November 1, 2022

ADDENDUM 2

Walnut Valley Unified School District
Diamond Bar High School
Building 400 Modernization New Classrooms/Library Media
DSA #03-121330 | File #19-H52

WALNUT VALLEY UNIFIED SCHOOL DISTRICT

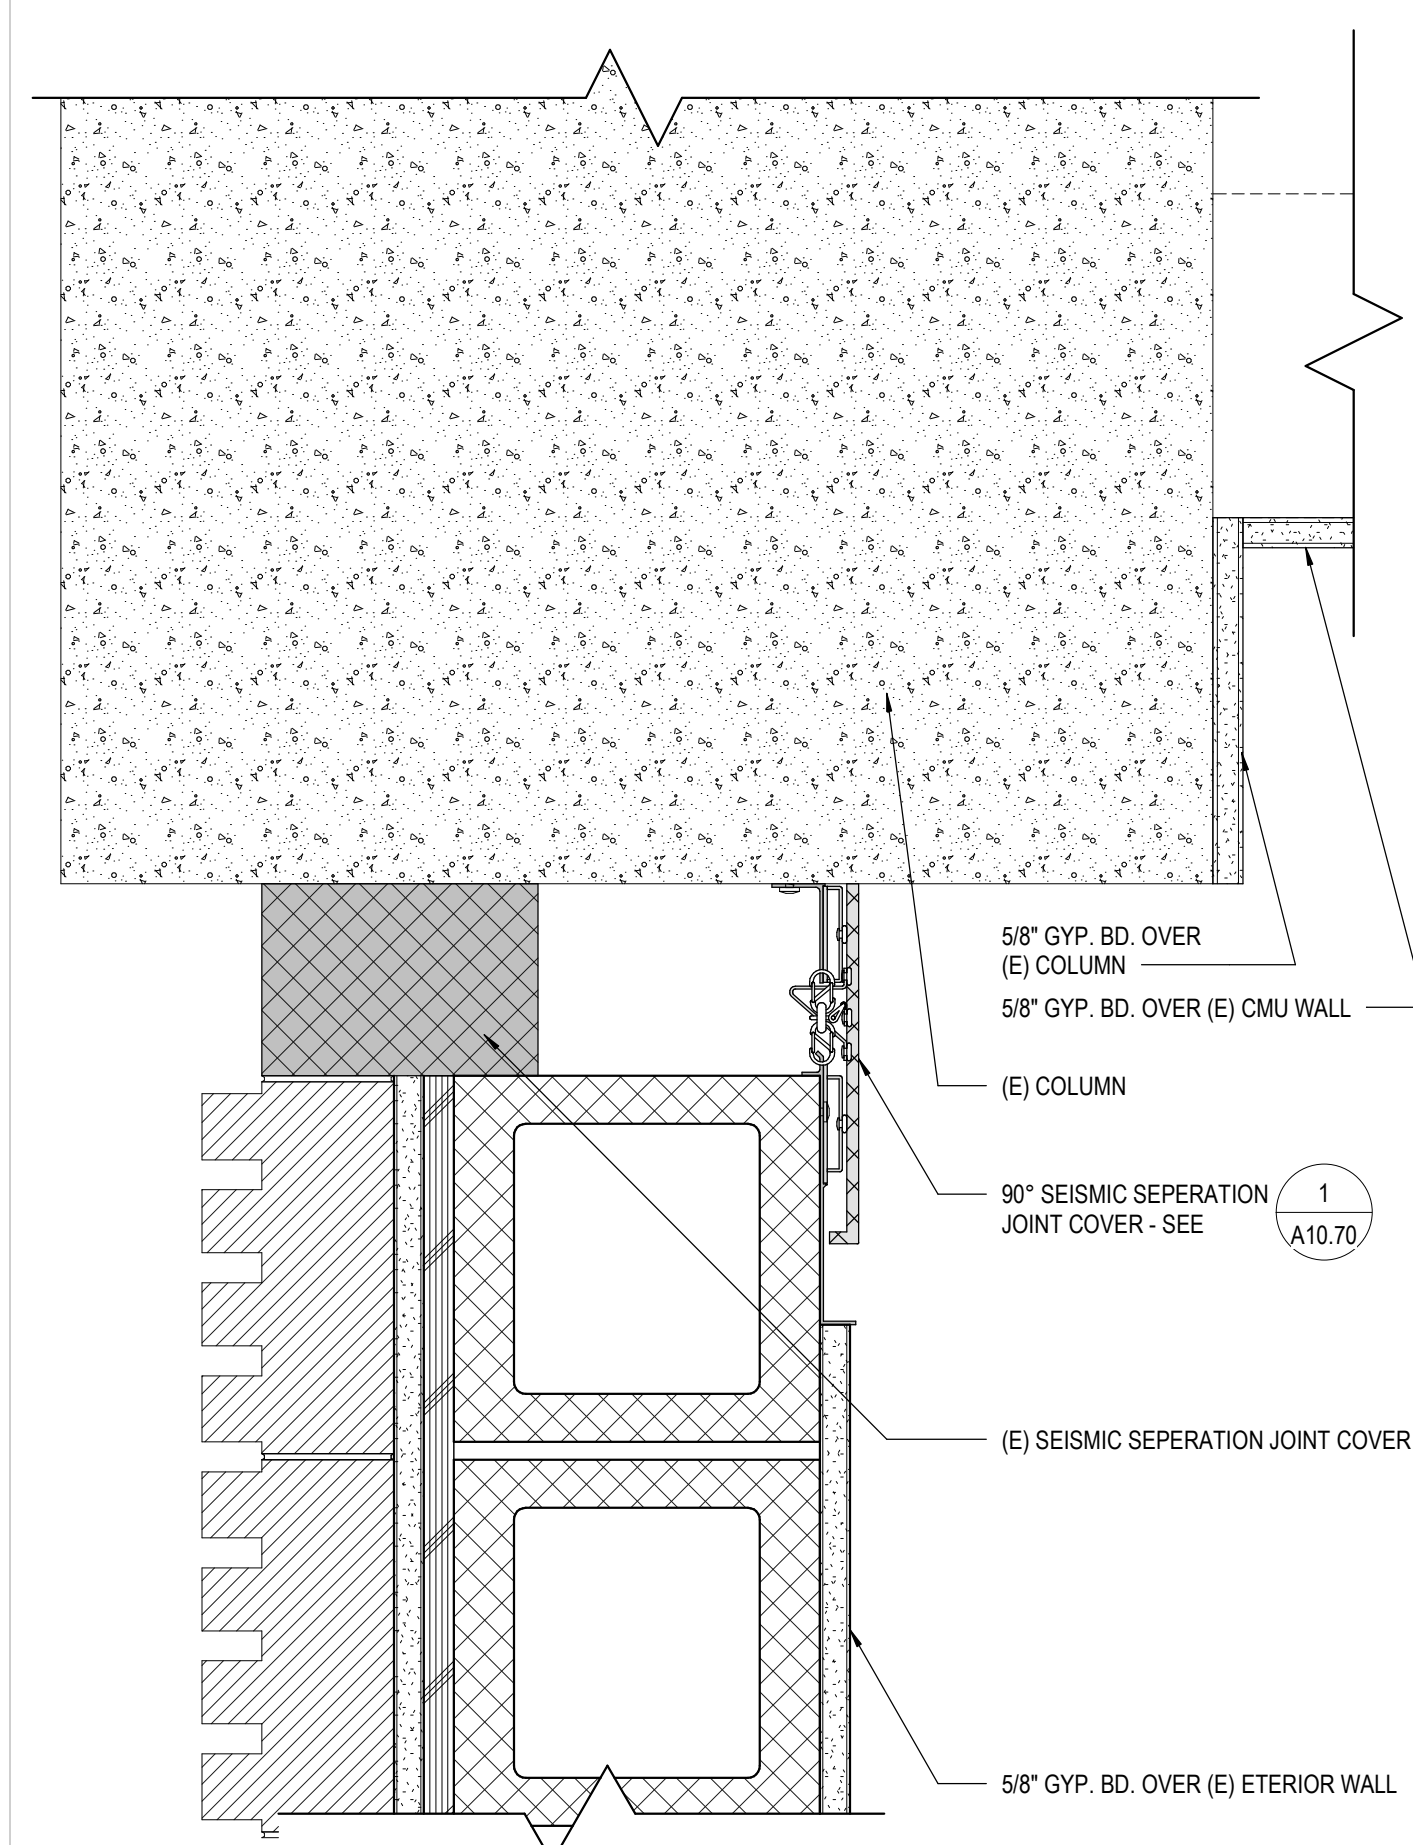
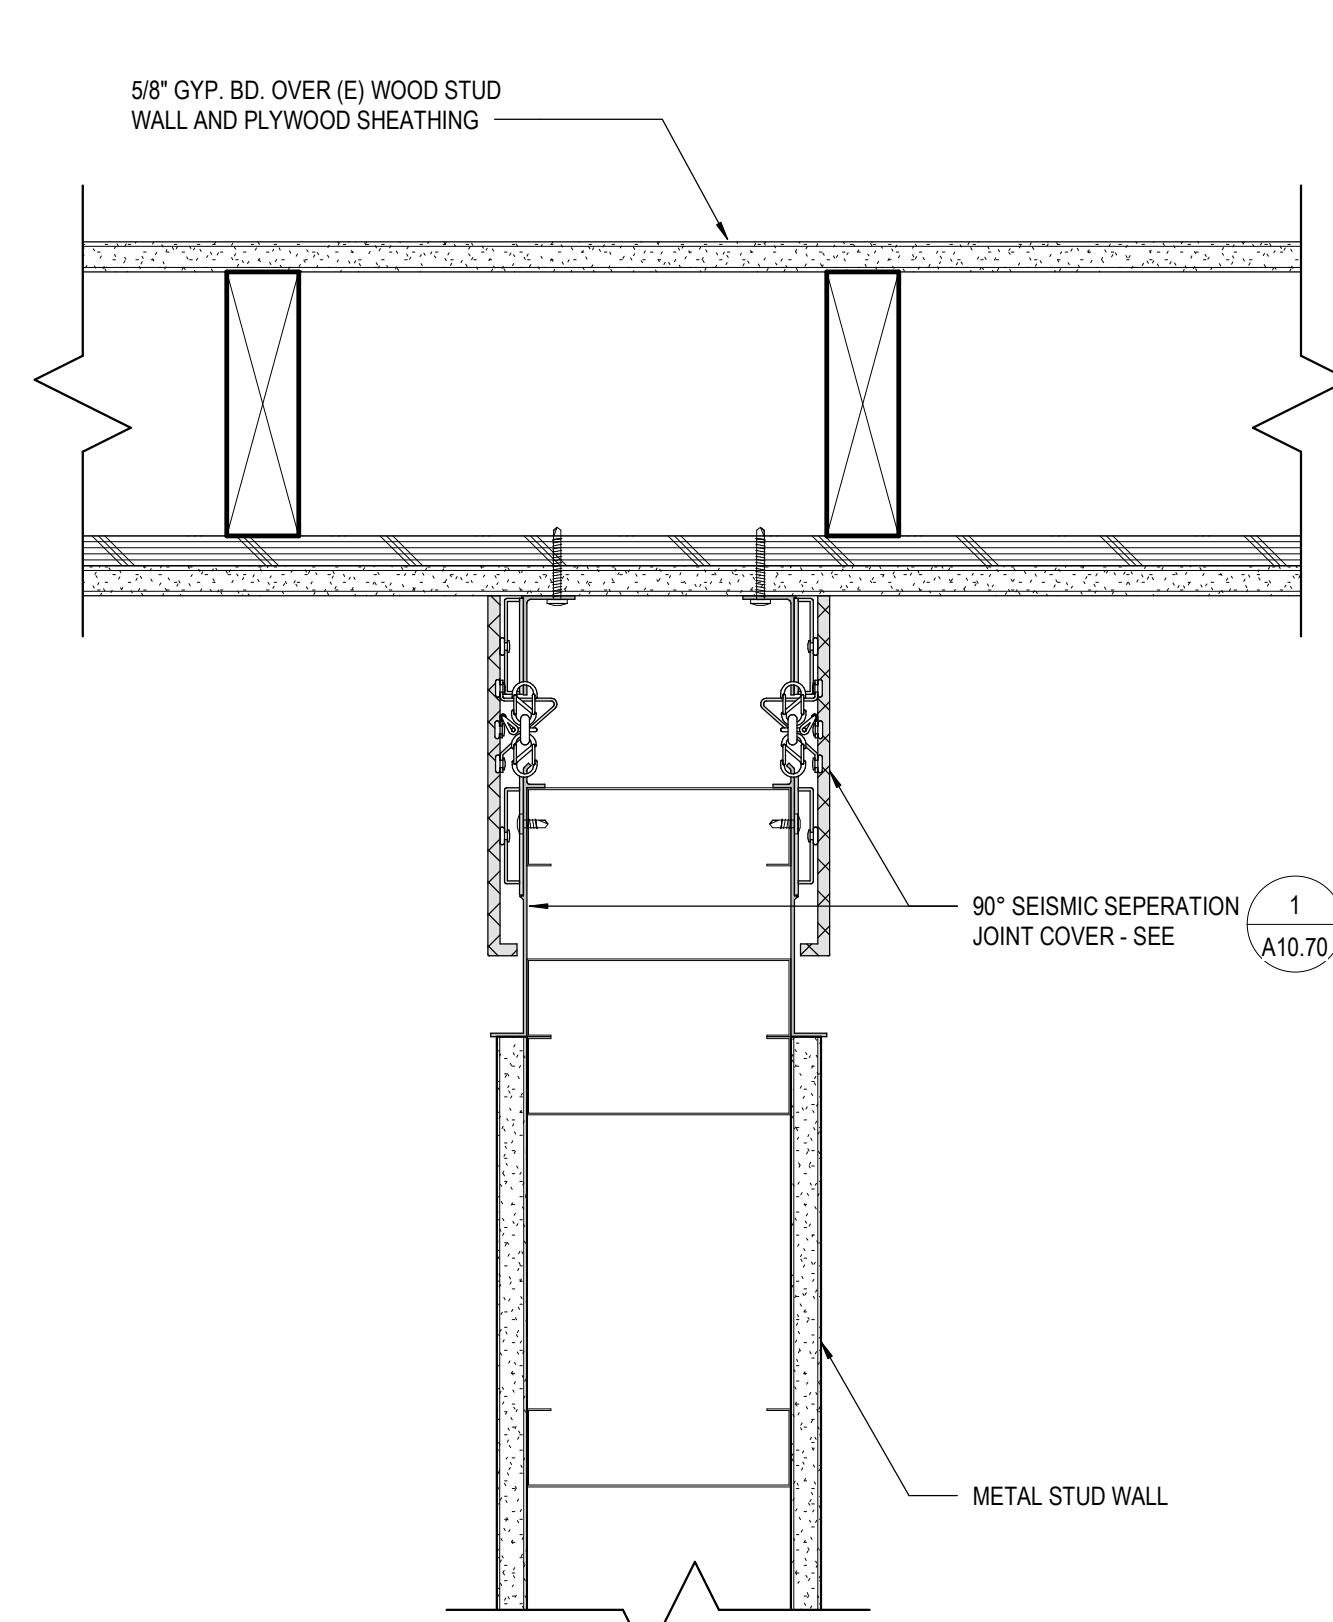
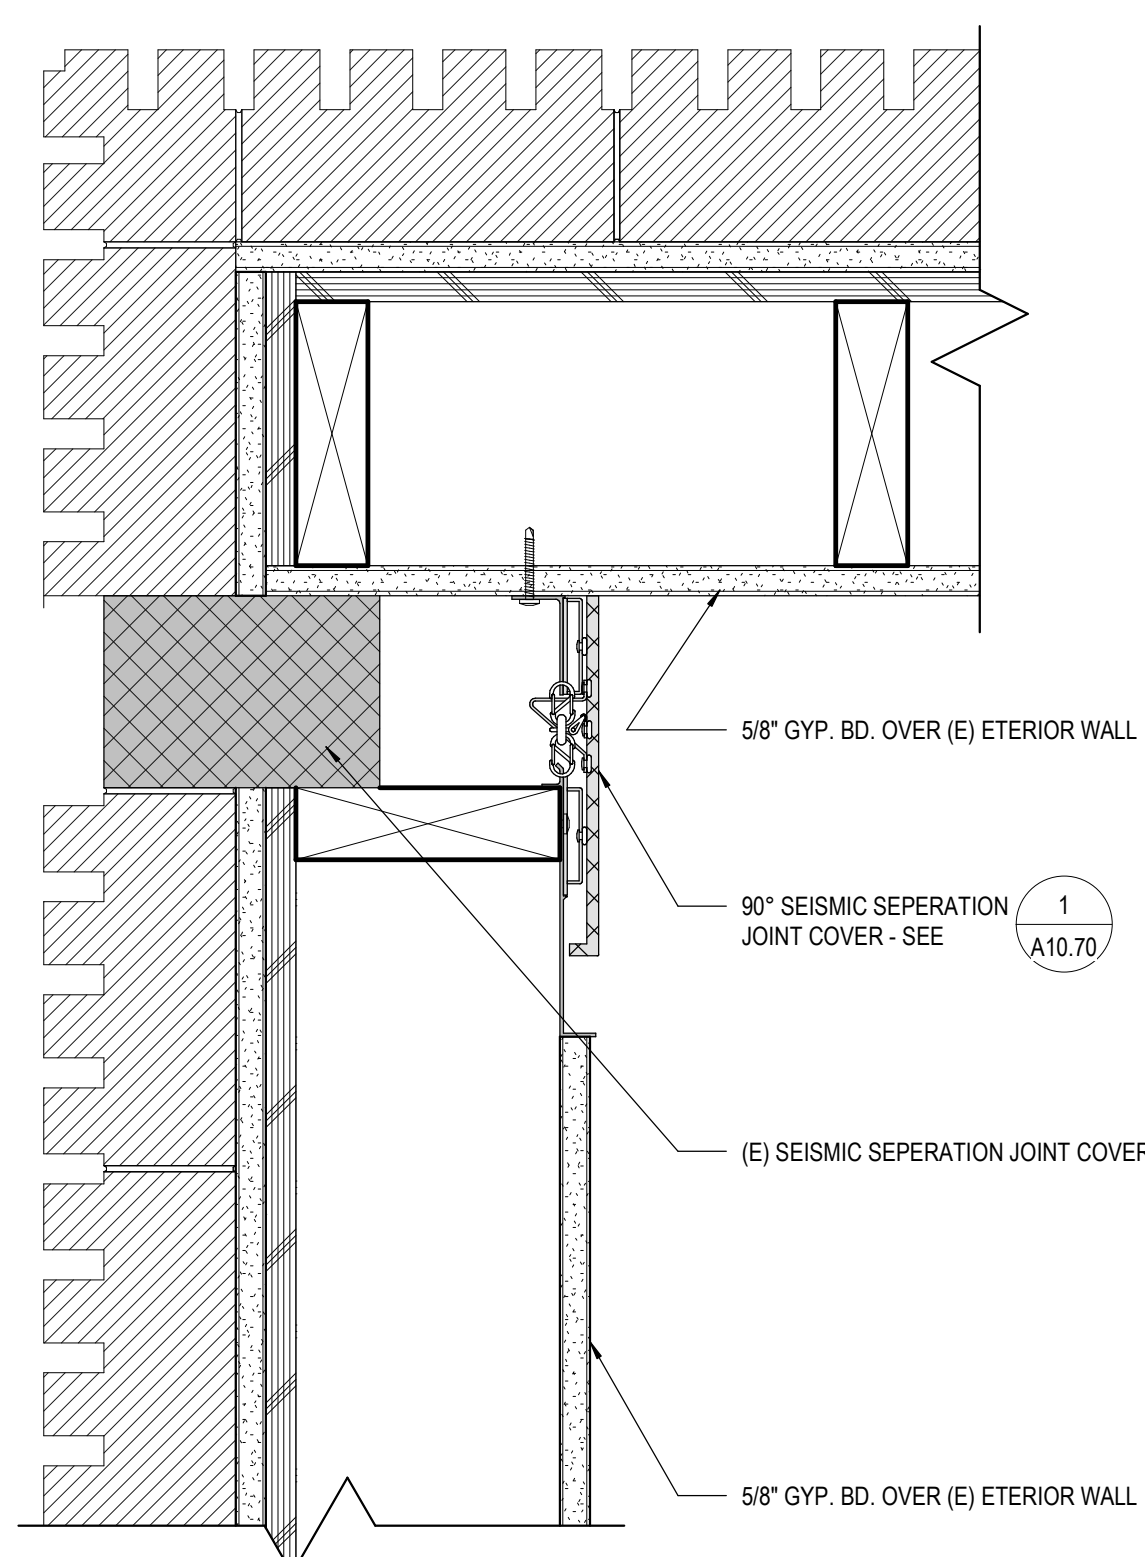
A10.31 CEILING DETAILS

- A. 5/A10.31: DELETED DETAIL. THE CORRECT DETAILS FOR THE SUSPENDED WALL AT THE SEISMIC JOINT ARE NOW DETAILS 3/A10.30, 8/A10.70, 13/A10.70 AND 18/A10.70 ISSUED IN ADDENDUM 1.

S202

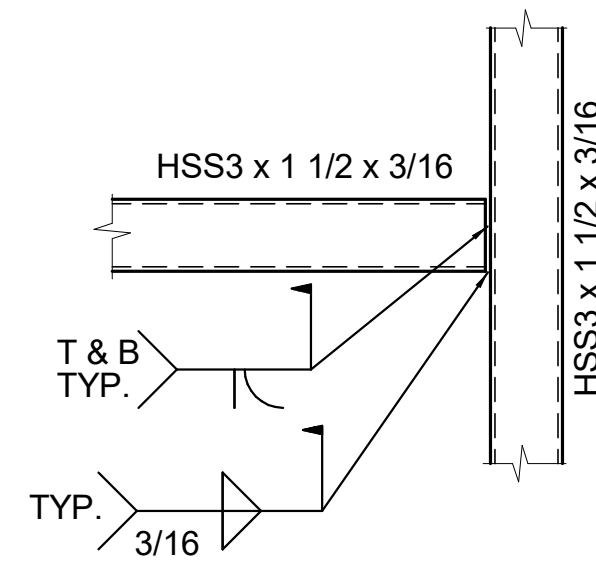
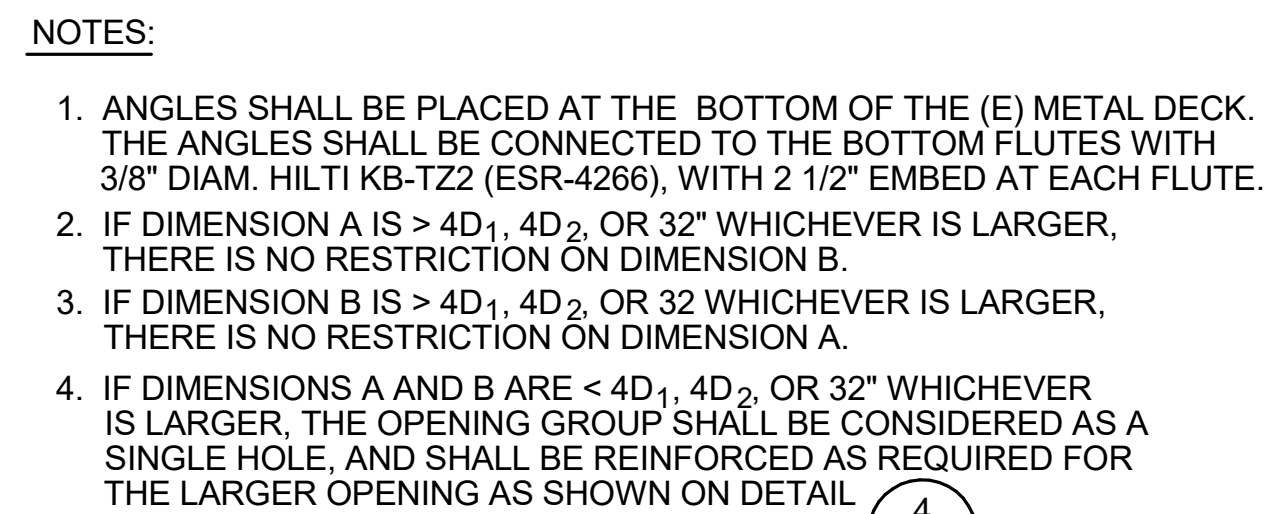
S202 (E) FRAMING PLAN – MAIN LEVEL

- A. CORRECTED DETAIL REFERENCE 12/S011 FOR INFILL AT EXISTING WALL OPENING (AT ONE LOCATION)
